Paragraph 6.2.3.2., amend to read:

Figure 3 in paragraph 6.2.3.2., amend to read:

Figure 3
Drop Orientations

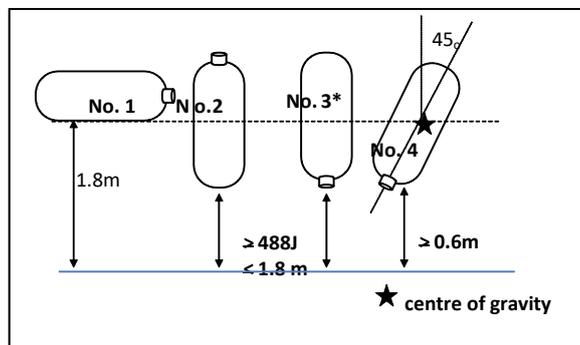
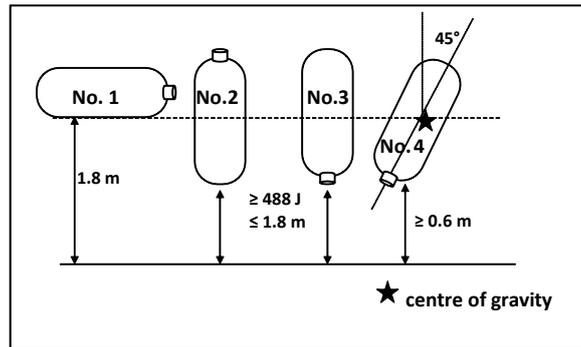
- (d) From a 45° angle from the vertical orientation with the shut-off valve interface location downward with its centre of gravity \leq at 1.8 m above the ground. However, if the bottom is closer to the ground than 0.6 m, the drop angle shall be changed to maintain a minimum height of 0.6 m and a centre of gravity \neq \leq at 1.8 m above the ground. In case of non-axisymmetric container, the line passing the shut-off valve interface location end and its centre of gravity shall be 45° angled from vertical orientation and the shut-off valve interface location shall become the lowest.

Amended:
